City of Surrey
PLANNING & DEVELOPMENT REPORT

File: 7912-0137-00

Planning Report Date: October 28, 2013

BINNING'S PLACE
 PROPOSED COMMERCIAL CORNER
 88 AVENUE & 128 STREET, VANCOUVER, BC
 SITE PLAN / SYNOPSIS / PERSPECTIVE VIEW
 DATE: 11-28-2023
 SCALE: 1:1000
 SHEET: 1 OF 1
 DRAWN: [Name]
 CHECKED: [Name]
 DATE: OCTOBER 2023

Landscaping

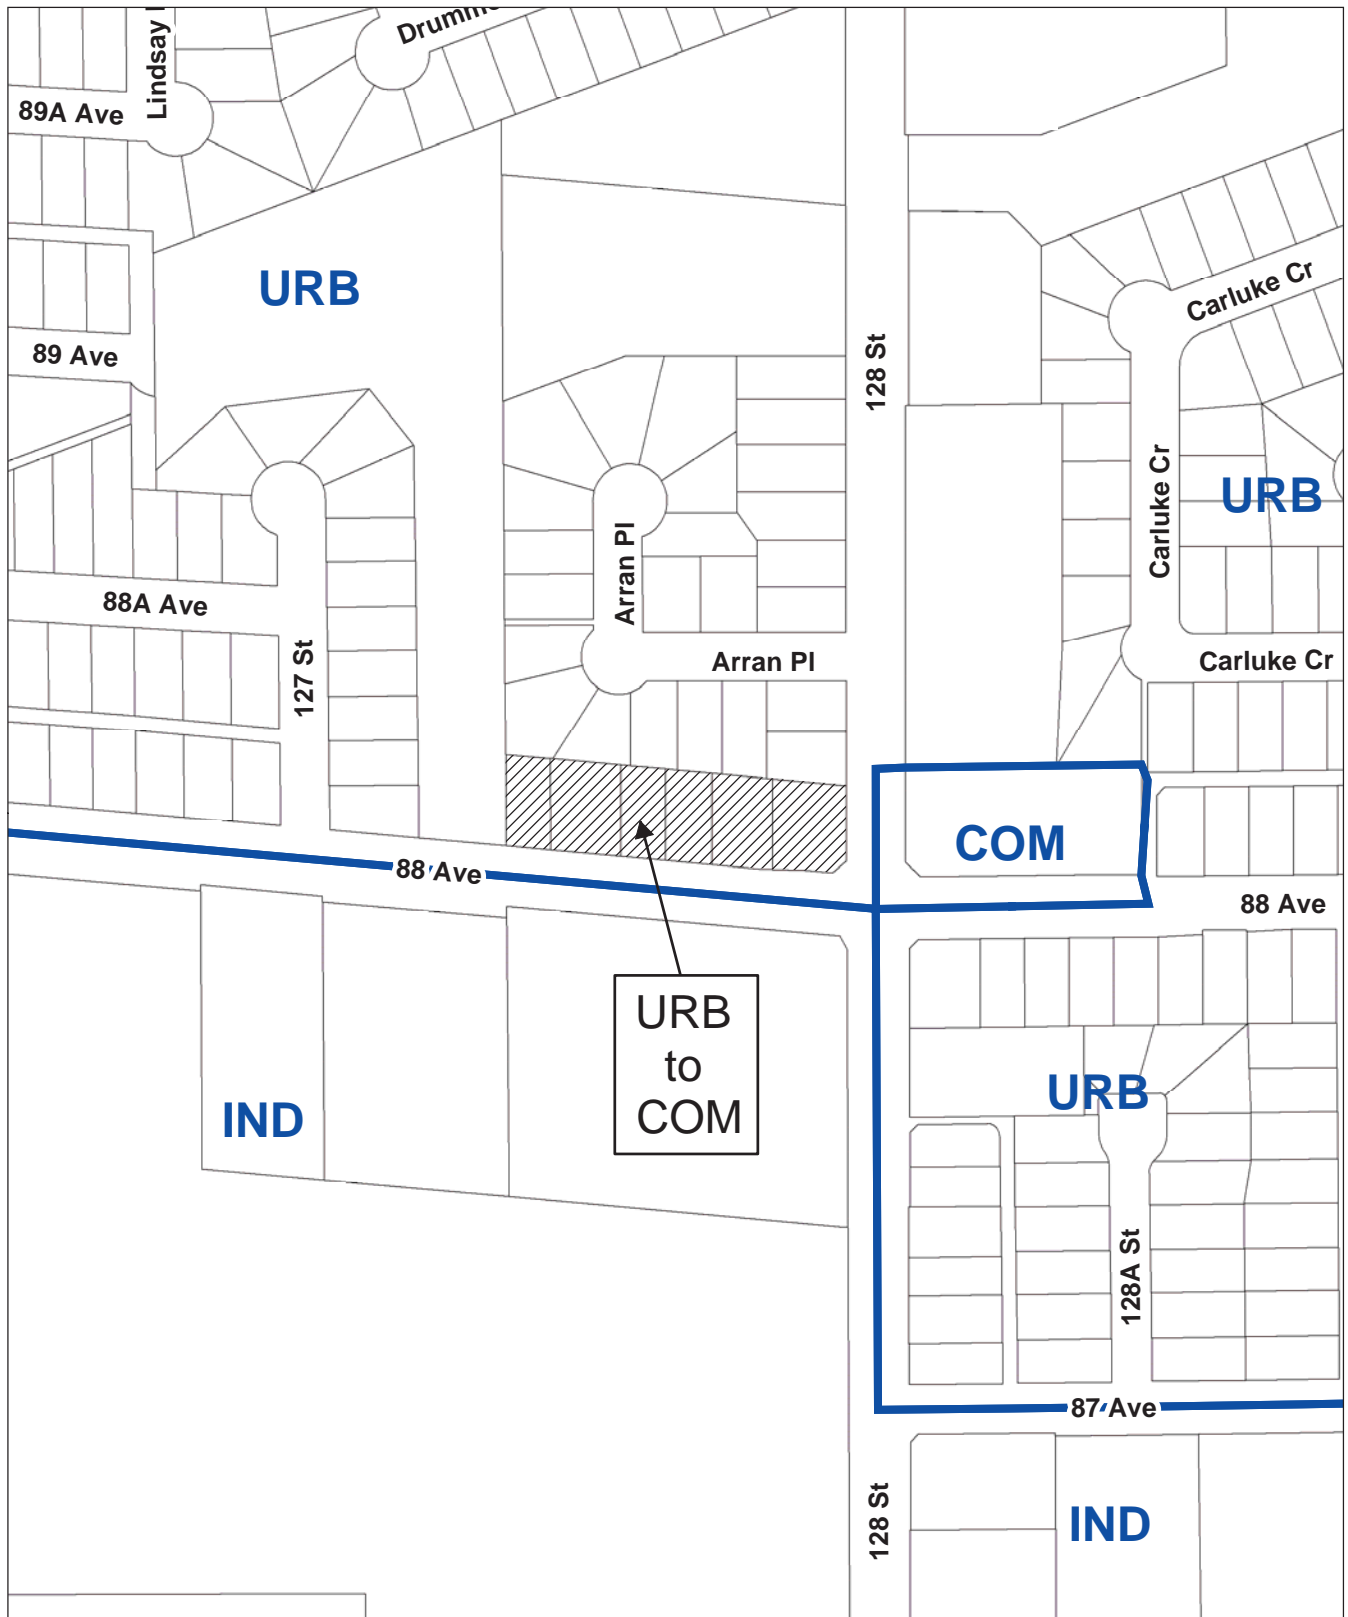
- Good effort to save trees.
- Make all parking the same material, i.e. permeable pavers.
 - Concrete pavers are shown on pedestrian areas only to differentiate them from vehicular areas. Permeable concrete is used on the Northern parking stalls as part of the preservation system for the neighbour's trees.
 - Standard asphalt paving is used for the remainder of the parking area and will be connected to a subsurface retention system to permit the water to seep into the soil.
- Widen 88 Avenue sidewalk, consider lower hedge on 88 Avenue.
 - The landscaping along 88 Avenue will be limited to 18 inch height, so as not to protrude above the store front glass.
 - The sidewalk adjacent to the building along 88 Avenue is limited to one meter by the space available.
